THE PRINCE GEORGE'S COUNTY GOVERNMENT

Re: Municipal Storm Drain
Acceptance Program
Town of University Park

MUNICIPAL STORM DRAIN ACCEPTANCE PROGRAM

MAINTENANCE REPORT

SUBDIVISION NAME University Park
 STREET: Wells PKwy
 200' SHEET NUMBER: 208 NE 3

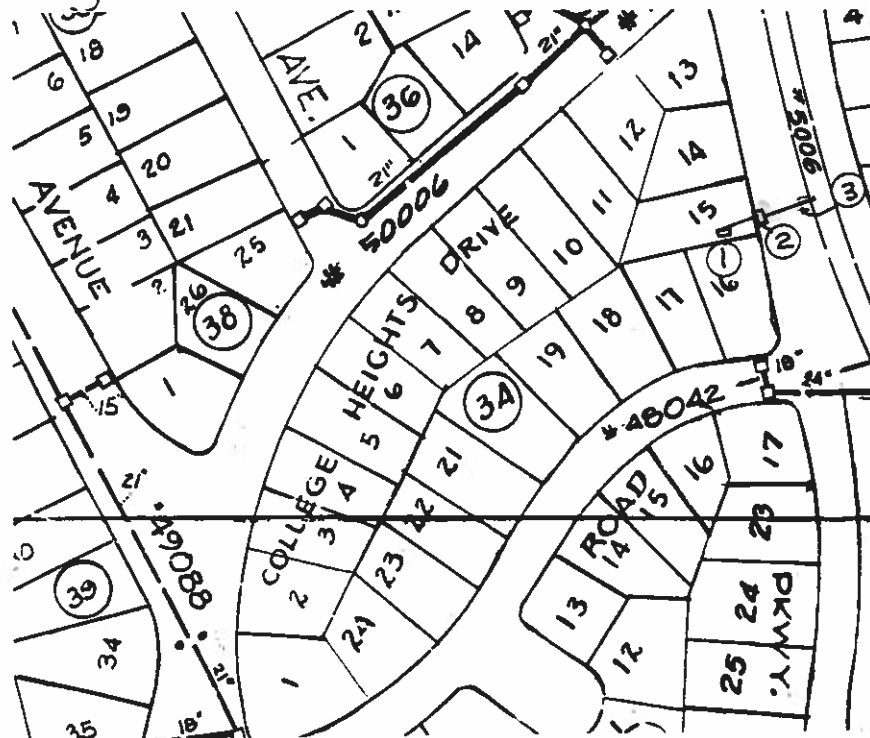
NUMBER	TYPE	PROBLEM	LOCATION
1	Yard inlet	located on private property, doesn't meet WPB std's.	Wells PKwy
2	curb inlet	none	Wells PKwy
3	outfall	no enwall structure	Wells PKwy

Recommendation: Accept inlet 2 and the outfall (#3); however do not accept #1 due to its location on private property and structure does not meet WPB standards.

SUBDIVISION NAME *University Park*
STREET: *Wells PKy, Van Buren St., Forest Hill Dr. (1 of 2)*
200' SHEET NUMBER: 208 NE 3

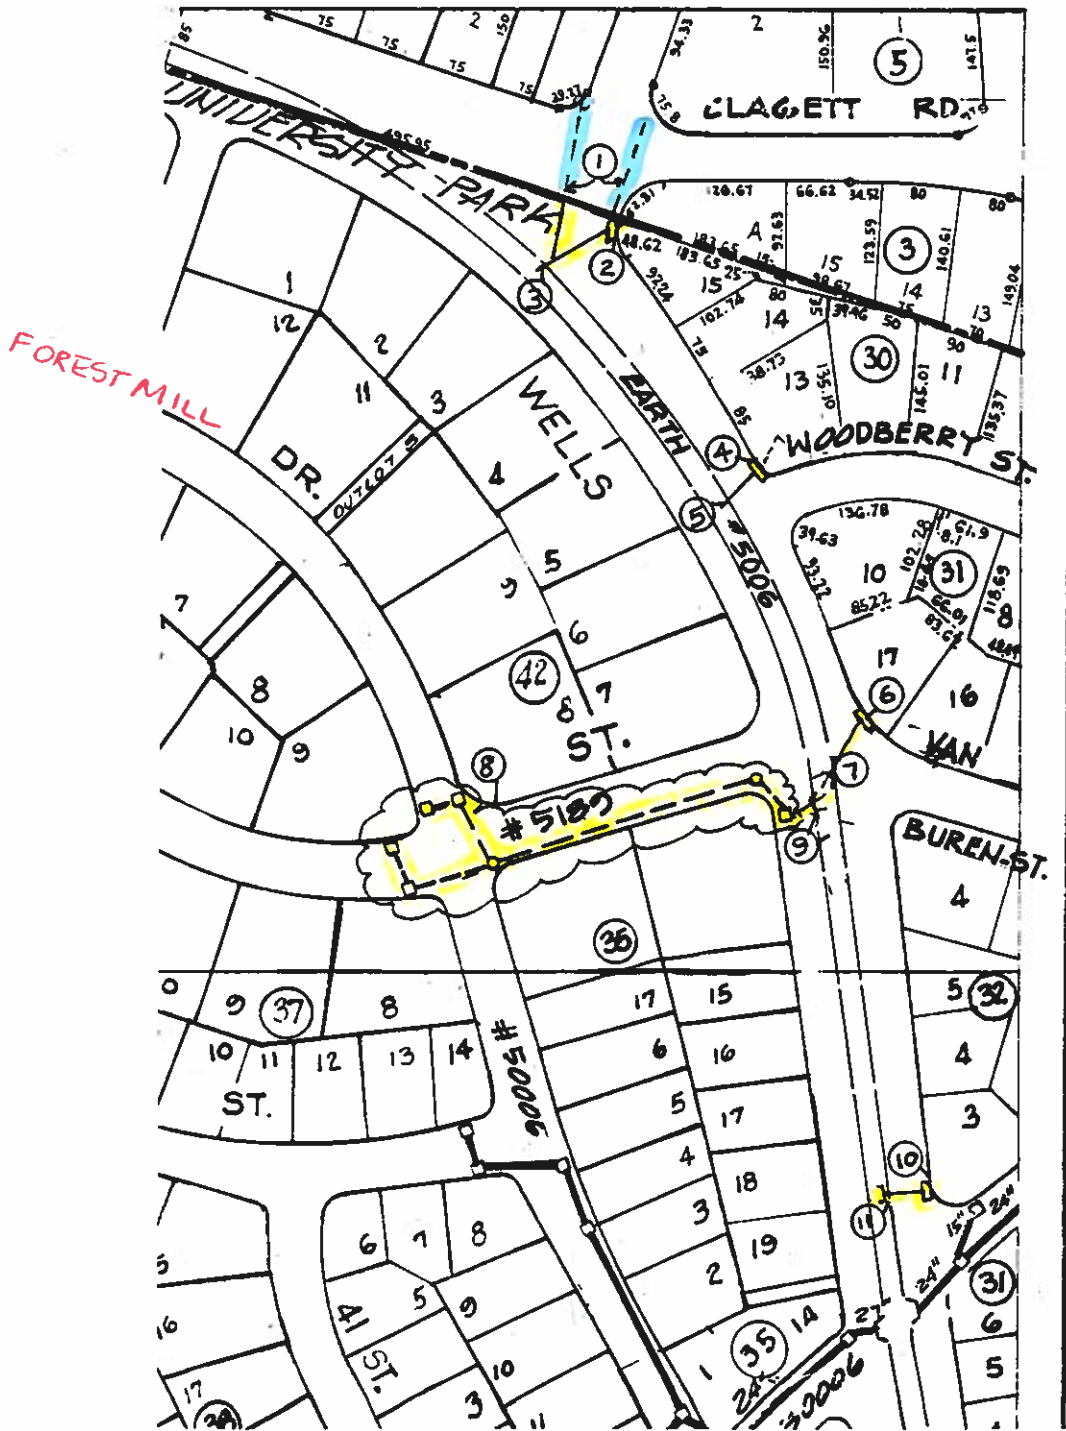
NUMBER	TYPE	PROBLEM	LOCATION
<i>1</i>	<i>Inflow pipes entering system from outside University Park.</i>	<i>none</i>	<i>Wells PKwy, Clagett Rd</i>
<i>2 4 6 10</i>	<i>curb inlets</i>	<i>not shown on 200' sheet</i>	<i>Wells PKwy</i>
<i>3 5 7 9 11</i>	<i>outfalls</i>	<i>not shown on 200' sheet, no endwall structures</i>	<i>earthen channel along Wells PKwy</i>
<i>8</i>	<i>Storm drain system numbered 5189 enclosed in </i>	<i>none</i>	<i>Van Buren St. & Forest Hill Dr.</i>

Recommendation: Accept all the storm drain shown that falls within University Park.

SUBDIVISION NAME *University Park*
STREET: *Underwood St., Queens Chapel Rd. (pg 1 of 3)*
200' SHEET NUMBER: *208 NE4*

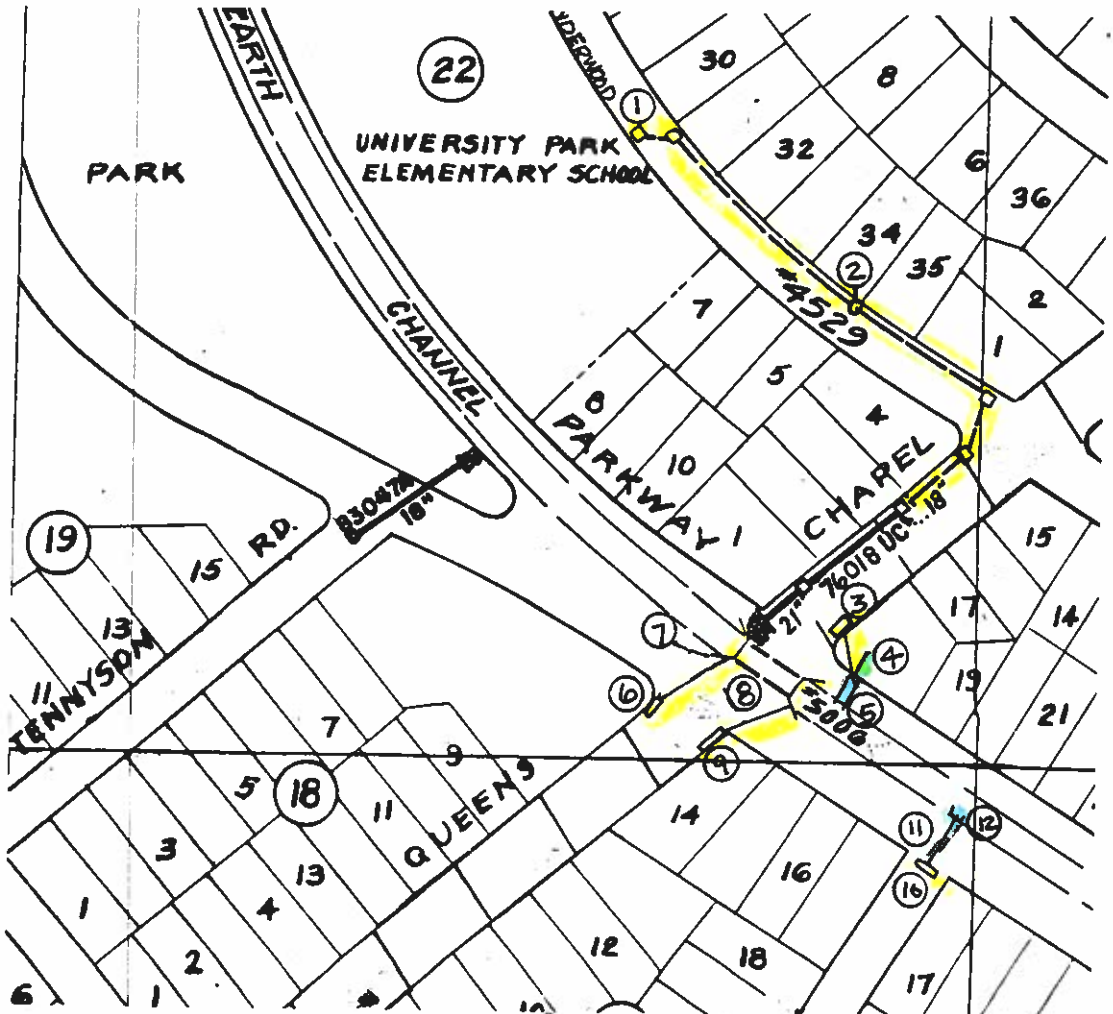
NUMBER	TYPE	PROBLEM	LOCATION
1	<i>curb inlet</i>	<i>debris</i>	<i>Underwood St.</i>
2	<i>manhole</i>	<i>none</i> <i>(not shown on 200' sheet)</i>	<i>Underwood St.</i>
3.	<i>WR inlet</i>	<i>none</i> <i>(installed by WMATA)</i>	<i>Queens Chapel</i>

NUMBER	TYPE	PROBLEM	LOCATION
4	Storm drain outfall	private WMATA drain for Emergency Escape tunnel.	Queens Chapel Rd.
5	grouted rip-rap outfall	doesn't meet WPB Std's.	Queens Chapel Rd.
6	WR inlet	none (installed by WMATA)	Queens Chapel Rd.
7	Outfall	none	Queens Chapel Rd.
8	Bridge	debris clogging 1 chamber of 2 chamber bridge	Queens Chapel Rd.
9	WA inlet	none	Queens Chapel Rd.
10	curb inlet	none	43 rd Ave
11	Storm drain pipe	RCP and CMP pipes CMP doesn't meet Std's	43 rd Ave
12	endwall	Soil under endwall is severely undermined	43 rd Ave

The storm drain pipe from inlet #10 (shown as #11 on plan) is CMP and doesn't meet standards. Outfall #12 is severely undermined and actively eroding. A good chance of pipe and structure failure exists at endwall #12.

The County will maintain only the waterway opening of #8 to convey stormwater, but will not structurally maintain the bridge.

Recommendation: Accept the entire storm drain system shown dotted from Underwood St. down Queens Chapel Rd. outfalling into 76018. (#1 and #2)
Accept the storm drain at the bridge on Queens Chapel Rd (#6, 7, 9, 3). Accept the inlet only at the end of 43rd Ave. (#10)

Not recommended for maintenance:
The private pipe from WMATA's emergency escape tunnel (#4) and the associated outfall (#5); due to non-standard grouted rip-rap outfall.

SUBDIVISION NAME *University Park*
STREET: *44th, Sheridan St., Route 40, Underwood St., Wells Pkwy*
200' SHEET NUMBER: *208 NE 4* *Tuekerman St. (1 of 5)*

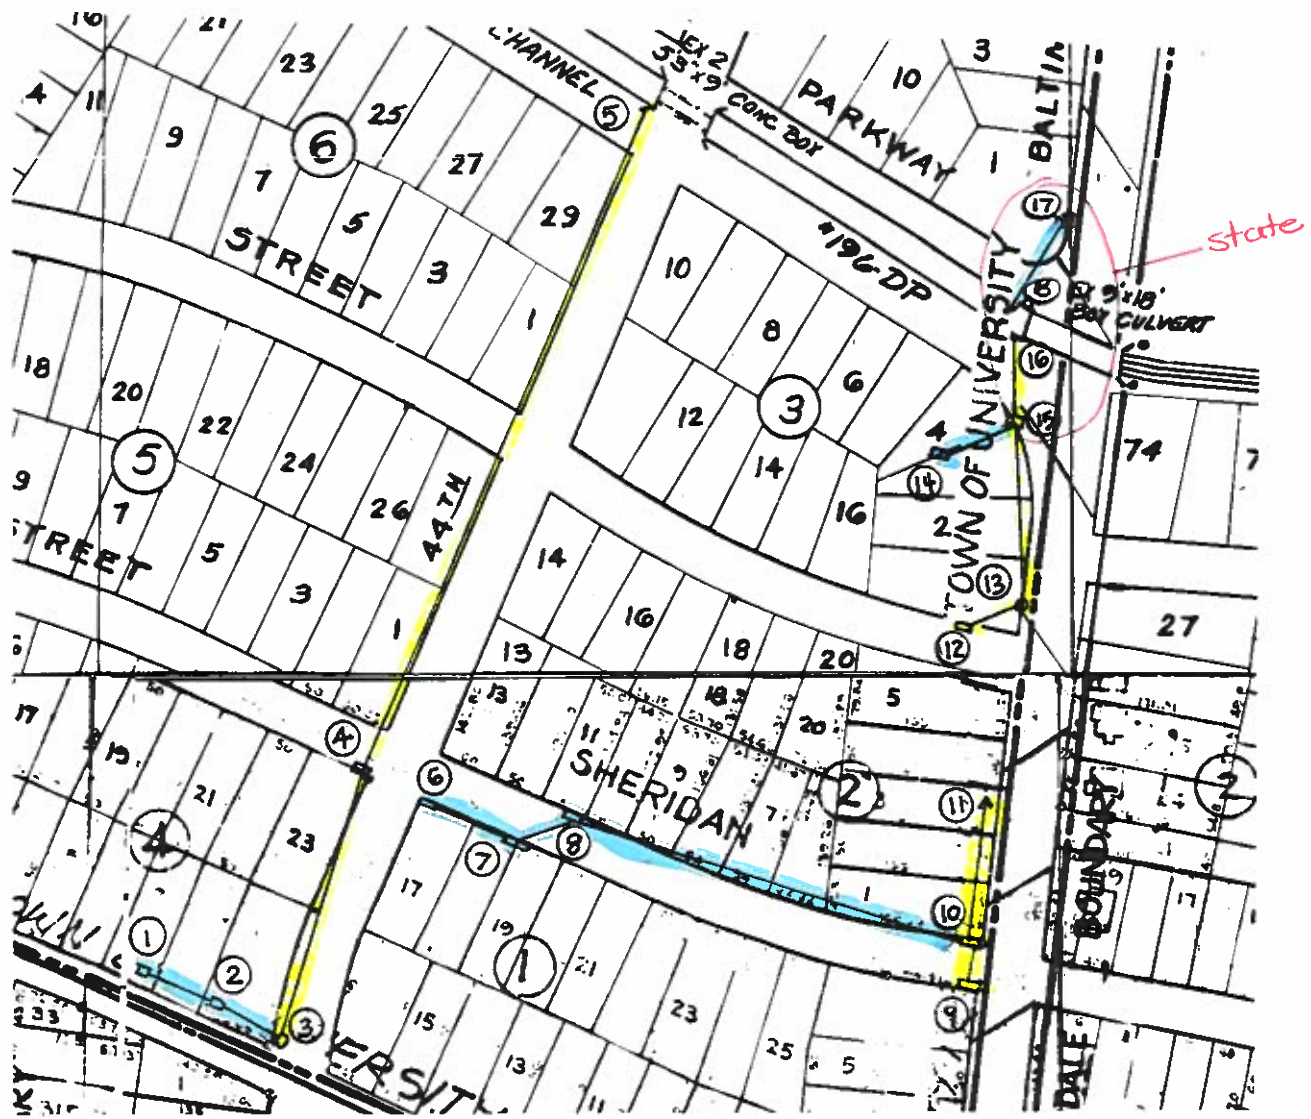
NUMBER	TYPE	PROBLEM	LOCATION
<i>1,2</i>	<i>yard inlets</i>	<i>not built to WPB stds, located on private property (not on 200' sheet)</i>	<i>East-West Hwy</i>
<i>3</i>	<i>manhole</i>	<i>(not shown on 200' sheet), on private property, SHC top may be on state property</i>	<i>44th and East-West Hwy</i>
<i>4</i>	<i>curb inlet</i>	<i>(not shown on 200' sheet)</i>	<i>44th and Sheridan St.</i>
<i>5</i>	<i>outfall into bridge wingwall</i>	<i>none</i>	<i>44th</i>
<i>6,7</i>	<i>curb inlet</i>	<i>completely clogged with debris (not shown on 200' sheet)</i>	<i>Sheridan St.</i>
<i>8,9,10</i>	<i>curb inlets</i>	<i>none (not on 200' sheet)</i>	<i>Underwood St.</i>
<i>11</i>	<i>storm drain</i>	<i>Unable to determine outfall location, pipe doesn't connect at structures 12 or 13 (not shown on 200' sheet)</i>

NUMBER	TYPE	PROBLEM	LOCATION
12	curb inlet	none (not shown on 200' sheet)	Tucker man St.
13	man hole	none (not shown on 200' sheet)	Route 1
14	curb inlet	located on private property, drains only church parking (not on 200' sheet) private system	Church Parking lot
15	curb inlet	none (not shown on 200' sheet)	Wells PKwy
16	into outfall bridge wing wall	none (not shown on 200' sheet)	Wells PKwy
17	WR inlet	located in STA R/W	Route 1
18	outfall	none (not on 200' sheet)	Wells Parkway

Do not accept the system on Sheridan St. numbered 6, 7, 8 and associated storm drain pipe to structure 10. The system is completely clogged with debris and has not functioned for an extended time period. The pipe inlets are not visible due to the formation of topsoil in the inlets formed from years of decomposing leaves. After the system is cleaned a determination of the condition of the pipe needs to be made. Since the system has not been functioning and no adverse effects have occurred thus far it may be possible the system is not necessary.

Inlets 9 and 10 may be sufficient to convey the storm water on Sheridan St.

Recommendation: Accept the storm drain line down 44th Ave from the manhole at Rt 410 (#3) to the outfall (#5) at the bridge, this includes the inlet at Sheridan St. # (4). Do not accept the yard inlets and associated storm drain pipe (#1 and #2) due to their location on private property and non conformance with standard construction practices.

Accept the inlets 9 and 10; however, during phase II the outfall of the system needs to be determined.

Accept inlet #12 on Tuckerman St, manhole #13, inlet 15, and the outfall into the bridge (#16) for maintenance. Do not accept inlet #14 and the associated storm drain pipe because it's on private property and receives runoff from the church parking lot only. (private system)

Do not accept inlet 17 because it drains Route 1. This is the State Highway Administration's responsibility. The County will maintain the outfall from the State's system #18; however, the County will only be responsible for insuring that the outfall remains free flowing not for the structural integrity of the outfall pipe.

SUBDIVISION NAME *University Park*
STREET: *Adelphi Rd.*
200' SHEET NUMBER: 208 NE 3

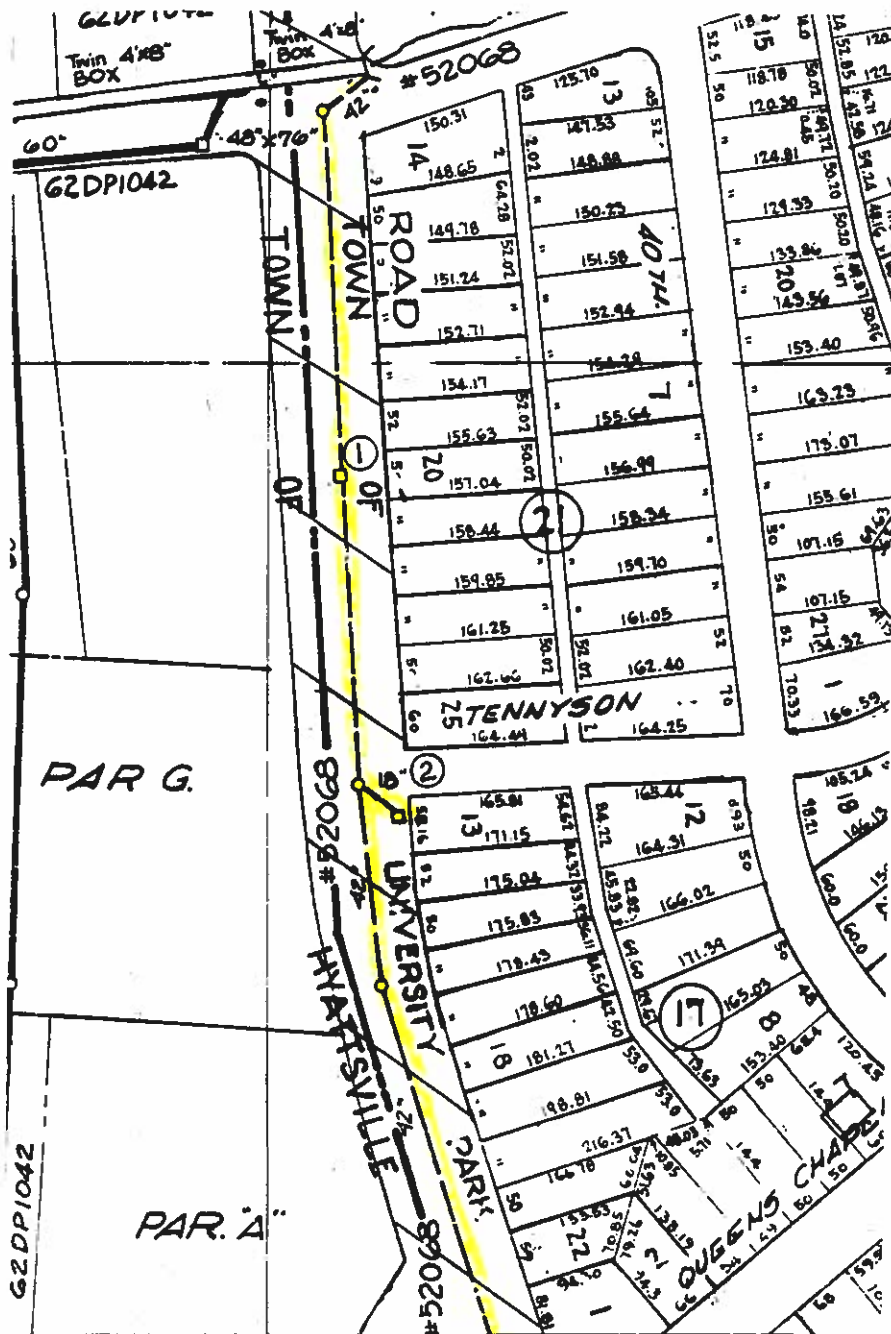
1. Inlet on Adelphi Rd was not locatable during field investigation

2. Curb inlet no problem located as shown on Adelphi Rd.

Recommendation:
Accept curb inlet along Adelphi Rd for maintenance
All storm drain in road R/W.

SUBDIVISION NAME *University Park*
STREET: *College Heights Dr., Beechwood Rd., Underwood Rd. (1 of 3)*
200' SHEET NUMBER: *208 NE 4*

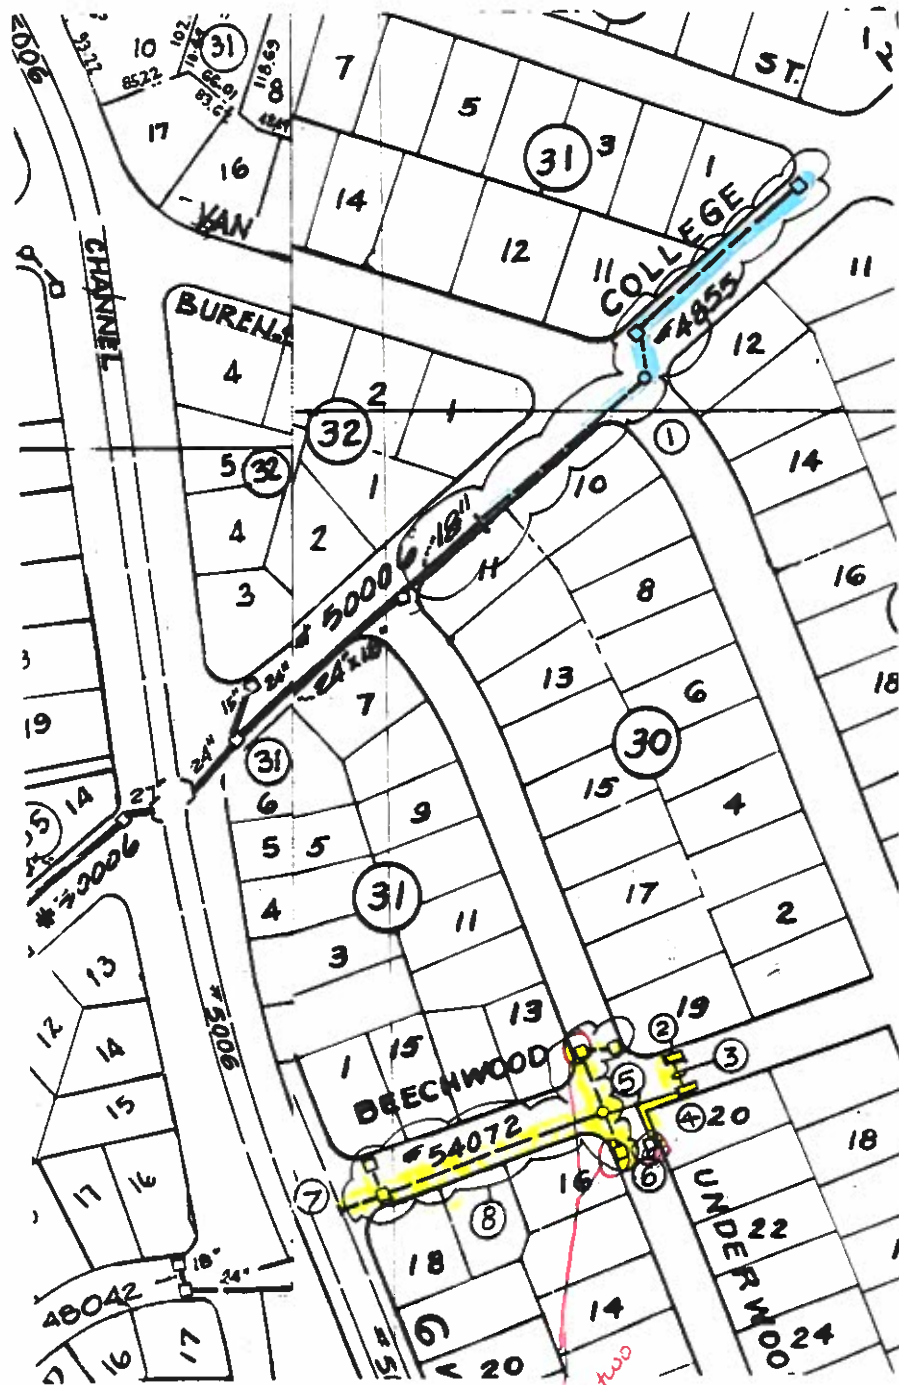
20
These two do not exist

NUMBER	TYPE	PROBLEM	LOCATION
1	Storm drain system	System doesn't exist	College Heights Dr.
2,3,6	curb inlets	not shown on 200' sheet	Beechwood Rd. & Underwood Rd.
3	storm drain pipe	pipe is PVC	Beechwood Rd.
5	manhole/F.C.	Storm drains connect within a manhole that's not locatable or a field connection not recorded.	Beechwood Rd.
7	outfall	none	Wells Parkway
8	storm drain system shown in 	none	Beechwood Rd. & Underwood Rd.

Recommendation: Accept entire system in Beechwood Rd for maintenance. WSSC repaired the pipe under Beechwood Rd. replacing broken pipe with PVC.

Remove dotted system on College Heights Dr. from 200' sheet.

SUBDIVISION NAME *University Park*
 STREET: *System in Clagett-Pineway, Pine Way (1 of 2)*
 200' SHEET NUMBER: *208 NE 4*

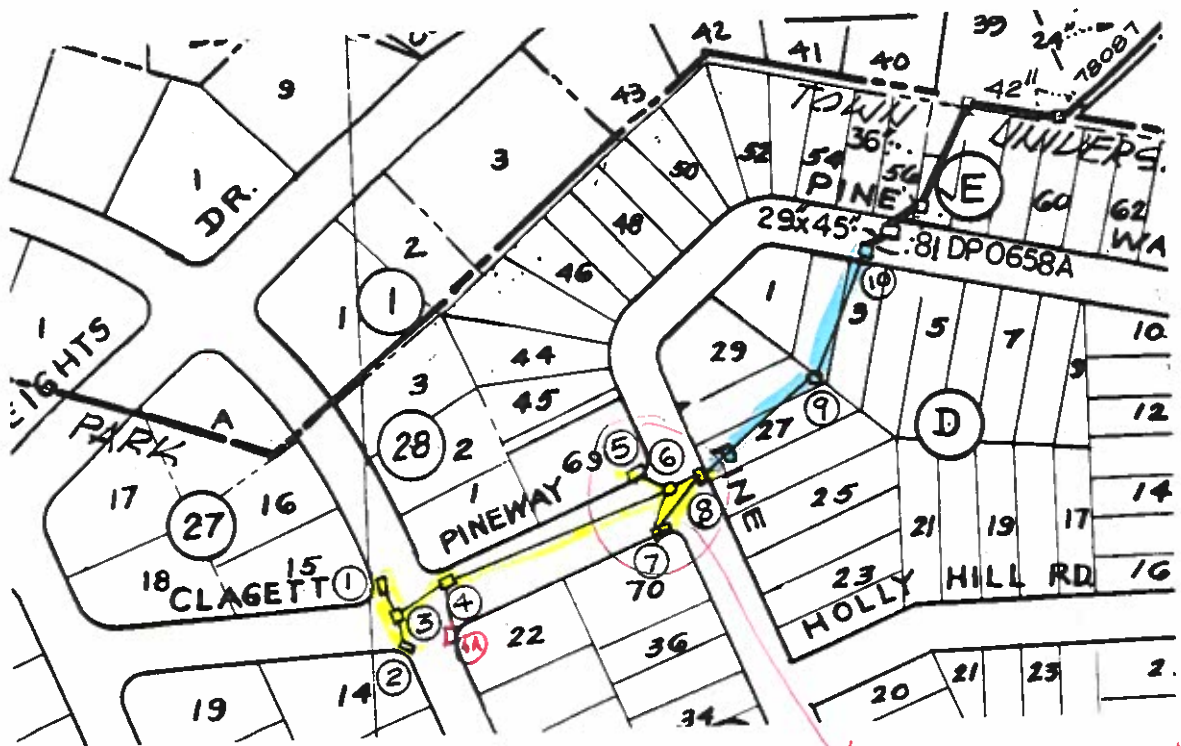
NUMBER	TYPE	PROBLEM	LOCATION
1 2 3 4	grate inlets	not shown on 200' sheet	Clagett - Pineway & Clagett Rd.
5 7 8	curb inlets	not shown on 200' sheet	Clagett - Pineway & Pine Way
6	manhole	not shown on 200' sheet	Pine Way

to be brought up to stds by DPW-T.

NUMBER	TYPE	PROBLEM	LOCATION
9	<i>Yard inlet storm drain from structure 8 to 10</i>	<i>inlet has cracked, doesn't appear to be a standard structure, located on private property</i>	<i>On lots 27 and 3 Pine Way</i>
10	<i>Storm drain</i>	<i>Void in the yard indicating the possibility of pipe failure</i>	<i>Lot 3 Pine Way</i>

Recommendation: Accept system on Clagett-Pineway and Pine Way located on public road. (Structures 1-8). Do not accept structure 9 and associated storm drain pipe located on private property. Structure 9 is substandard and broken. The storm drain pipe appears damaged and undersized due to location in sump area with inadequate 100 year overflow path.
